The Drovers Solar Farm

Statement of Common Ground (SoCG) with Natural England (Tracked)

Document reference: APP/5.15.1 (Revision 1)

Plate 11-23 Provisional ALC, Site circled approx.

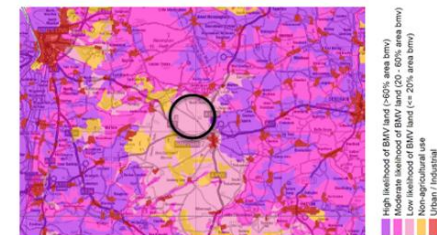
<u>schemes identified in Appendix 2.4 of the ES [APP/6.4.1].</u> <u>Therefore, the Applicant considers that the ES does capture the combined and cumulative impacts of the different components of the Scheme, and considers that item (ii) can be agreed.</u> <u>Reliance Upon Provisional ALC Maps.</u> In <u>[RR-038] NE comment at NE8 that provisional ALC plans do not identify if land is of BMV quality or not. The limitations of the (then) published provisional ALC maps, and the Likelihood of BMV maps, is clearly recognised. Short of detailed ALC, it was, however, the best data available, and NE had digitised it so it was clearly intended to be used. The Site can be seen as the lowest quality available, Grades 3 and 4, and with a low likelihood of BMV, unlike much of Norfolk.</u>	
--	--	--	--	--

Comment NE8 in [RR-038] goes on to set out the limitations of provisional ALC mapping, advising that the results of a detailed ALC survey would provide soils data. This comment is not disputed. It is believed that these comments in the Relevant Representations have fed into the concerns raised in the SoCG. Given that detailed ALC survey and soil survey was fully reported in the ES, the Applicant considers that item (iii) should be capable of being agreed.
